Response to the Reviewers' Comments

The authors would like to thank the reviewers for the precious comments and suggestions on the technical contents and presentation of our manuscript “Runtime Power Management of Battery Electric Vehicles for Extended Range with Consideration of Driving Time,” submitted to IEEE Transactions on Very Large Scale Integration (TVLSI.) This revised manuscript has been greatly improved thanks to the reviewers’ invaluable advices. We have revised the manuscript faithfully following the reviewers’s comments. We include the newly added or significantly modified parts in the revised version of the paper also in Response to Reviewers. We highlight the important technical content changes and set those parts in a red color in the revised paper.

Fig. 2: (a) Range-speed experimental data for Chevrolet Bolt [36] and (b) comparison with simulation results of the proposed EV power model.

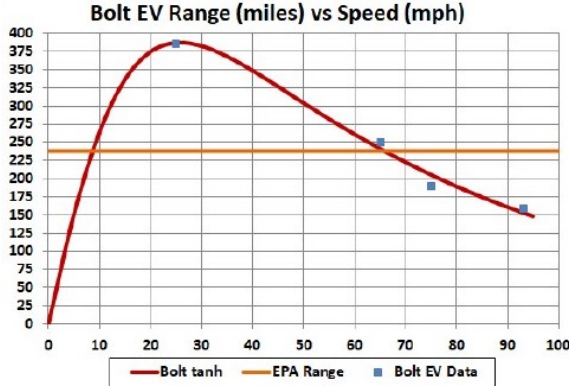
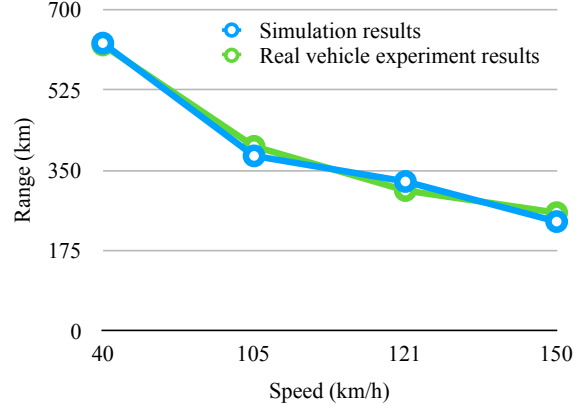
R1-C2 It is not clear how to validate the power model of EV. As the author mentions that accuracy of power model is quite important, it is good to see the power model in this paper can be validated by some real measurement results.

R1-A2 Previous eco-driving research is optimized for ICEVs that mandate a (variable-speed) transmission, and thus the resultant eco-driving is not applicable to EVs as we demonstrated in this paper. We previously introduced an

Here goes how we extracted correct coefficients of the EV power equation. We use ADVISOR to extract the model coefficients of new vehicles starting from known vehicle specifications such as the aerodynamic resistance, rolling resistance, curb weight, and so on. Such data is often published in the users' manual, website and so forth. We further use the vehicle performance data such as the top speed, maximum acceleration, and so on, which are also available on the manuals, commercials and websites. We iteratively run ADVISOR and derive the model coefficients so that all the known data values match among each other. The model coefficient extraction result shows as in Fig. 1. The normalized root-mean-square (RMS) deviation is 5.1%. Table I summarizes the model coefficients of (5) for Chevrolet Bolt.

We further evaluate the model accuracy with the range-speed real vehicle experiments as shown in Fig. 2(a) to confirm the derived power models are close enough to the real vehicle measurement data [32], [33], [34], [35], [36]. We refine the coefficients until all the available data values match well.

As a result, the derived EV power model well matches with the range-speed experimental data as shown in Fig. 2(b) as well as the top speed and maximum acceleration setting the aerodynamic resistance, rolling resistance, curb weight, etc. with the known values. The errors in the range-speed simulation is merely 1.4%, the time for 0-to-100 km/h error is 7.8%, and the top speed error is 3.0%, respectively. We revised the manuscript adding the following paragraph with a new figure in Section III.A on page 3 and 4.

Fig. 12: Velocity profile comparison with EDP , E^2DP and E^3DP on Serrano Avenue in Anaheim Hills.

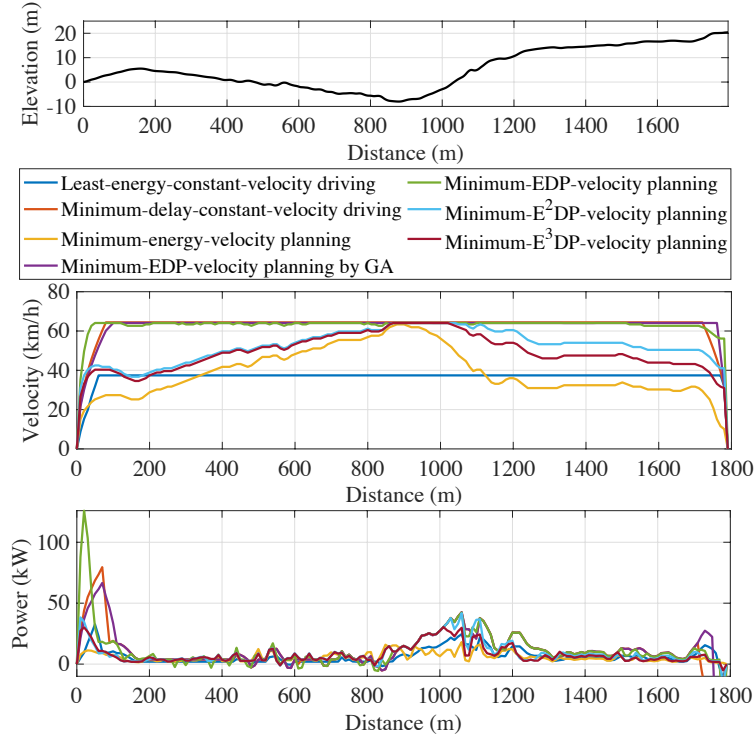
R1-C3 The optimality of the proposed scheduling algorithm is unclear. The author should add several paragraphs to discuss this topic. It is also to see the comparison baseline is well accepted to show the advantage of the proposed algorithm.

R1-A3 As we already mention in the previous version of the manuscript, the proposed EDP-aware-velocity planning is not optimal. This is because the EDP-aware-velocity planning is not formulated as DP (we also mentioned this in the previous version of the manuscript), but we used DP referring it as "heuristics." We demonstrated that such heuristics method still very well reduces EDP , ED^2P and ED^3P . However, as the reviewer pointed out, there was no tangible clue how the resultant solutions are close to the true optimal.

We also updated Fig. 12 and Fig. 13:

Fig. 11: Histograms of velocity and acceleration for the proposed energy-aware-velocity planning methods without an acceleration constraint (a) and (b) and with an acceleration constraint (c) and (d), respectively.

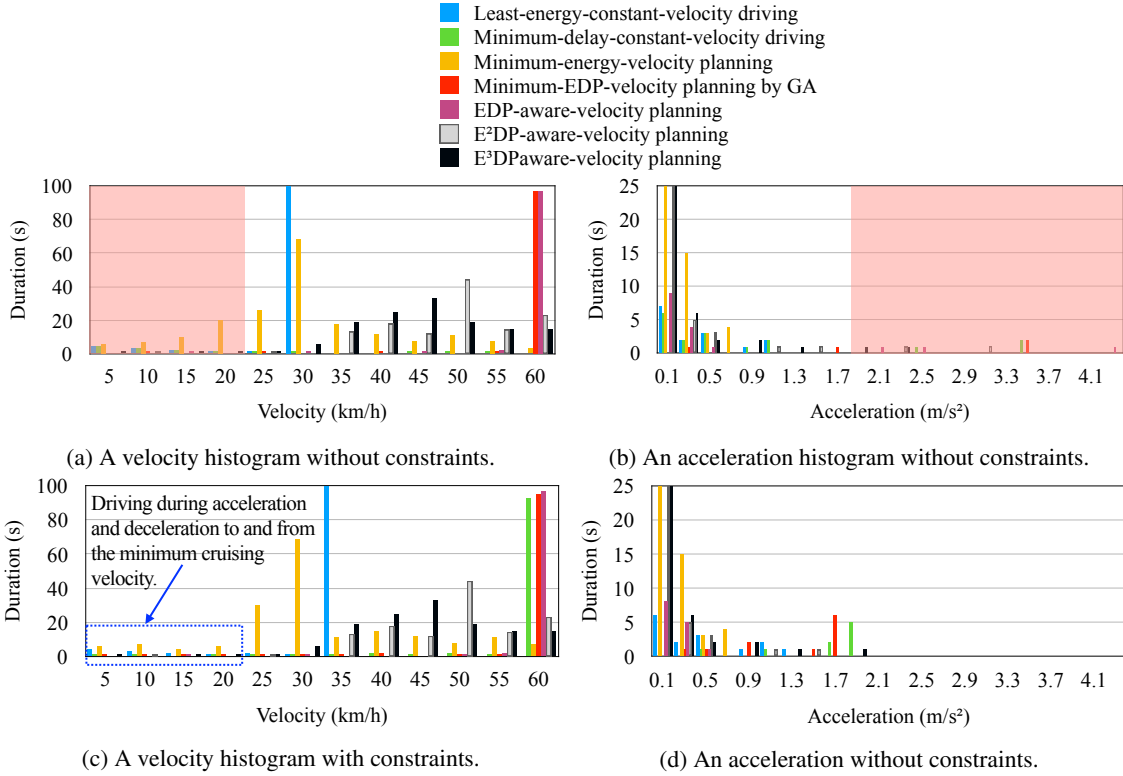
R2-C2 It would be good to have more discussion on the assumptions of the approach and the experiments, e.g., how much can the velocity be changed in practical scenarios without impeding traffic and causing unsafe situations (also depending on the road conditions and whether it is urban or rural environment I suppose). Currently, there only seems to be one constraint on not slower than 10 km/h.

Like the minimum-energy-velocity-planning, E^2DP - and E^3DP -aware-velocity planning methods may result in a too low cruising velocity, which bothers traffic as well as extends the driving time too much, and a too high acceleration may cause passenger discomfort. We add the velocity and acceleration constraints after first time running the DP.

We quantize the velocity and acceleration values and make a histogram to analyze population of velocity and acceleration for the proposed energy-aware-velocity planning methods. Fig. 11(a) and (b) show two histograms of the driving schemes in Fig. 12, which do not have velocity and acceleration constraints. We avoid a cruising velocity lower than 25 km/h and an acceleration higher than 2.0 m/s^2 in this paper without loss of generality. The acceleration of 2.0 m/s^2 is the same as the maximum acceleration of compact cars designed to be used primarily used in urban areas (13 seconds of 0-to-100 km/h time).

Fig. 11(c) and (d) shows the velocity and acceleration histograms with the constraints. Once we run the DP for the first time without constraints, we analyze the histogram, adaptively determine the minimum cruising velocity and maximum acceleration constraints, and run DP again. We keep the same constraints for online recomputation whenever unexpected interrupts occurs.

We also enforce the minimum acceleration not lower than 1.0 m/s^2 when the EV starts from a stop sign or a traffic light until the velocity reaches to the minimum cruising velocity not to bother traffic flow. The acceleration of a 1.0 m/s^2 exhibits 6 second delay to reach 25 km/h. The maximum speed is bounded by the speed limit of each road benchmark.

Fig. 8: Altitude changes in the real road benchmarks.

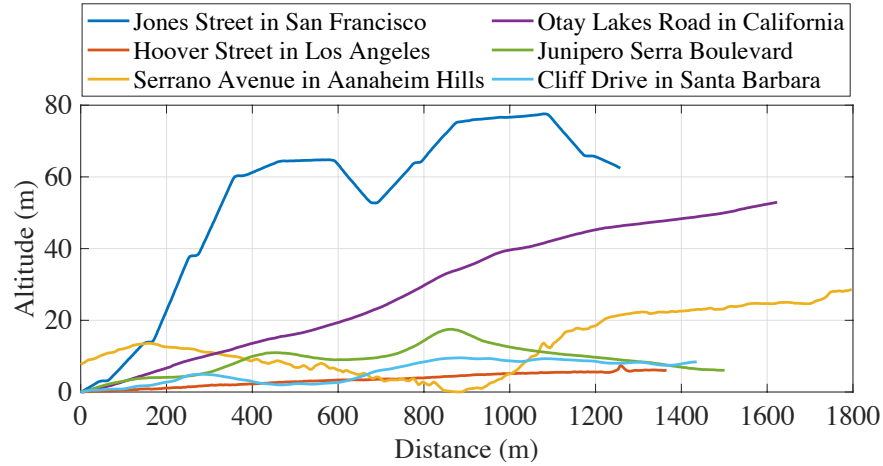
R2-C3 Related to the last point, it would be good to have more discussion on the road benchmarks, e.g., how they are generated and how representative they are. The optimization results significantly depend on road slope. It would be good to use a variety of real road segments for testing.

R2-A3 We appreciate the reviewer's comment. We replaced the previous synthetic road benchmarks with the real road benchmarks. We made six new real road benchmarks from various locations in California. The first three roads are in cities. Jones Street in San Francisco and Hoover Street in Los Angeles are two representative city landscapes such as hills and flat roads, respectively, and Cliff Drive in Santa Barbara is a mixture of those. The second two roads are in mountain areas: Serrano Avenue in Anaheim Hills and Otay Lakes Road in San Ysidro Mountain in California. The last road is Junipero Serra Boulevard connecting San Francisco and San Jose. The details of road data is summarized in Table II, and Fig. 8, which visualize the altitudes of the road benchmarks. We also revised all the associated contents with the new real road benchmarks.

We choose six roads from various locations in California and make real road benchmarks. The first three roads are in cities. Jones Street in San Francisco and Hoover Street in Los Angeles are two representative city landscapes such as hills and flat roads, respectively, and Cliff Drive in Santa Barbara is a mixture of those. The second two roads are in mountain areas: Serrano Avenue in Anaheim Hills and Otay Lakes Road in San Ysidro Mountain in California. The last road is Junipero Serra Boulevard connecting San Francisco and San Jose. The details of road data is summarized in Table II, and Fig. 8, which visualize the altitudes of the road benchmarks.
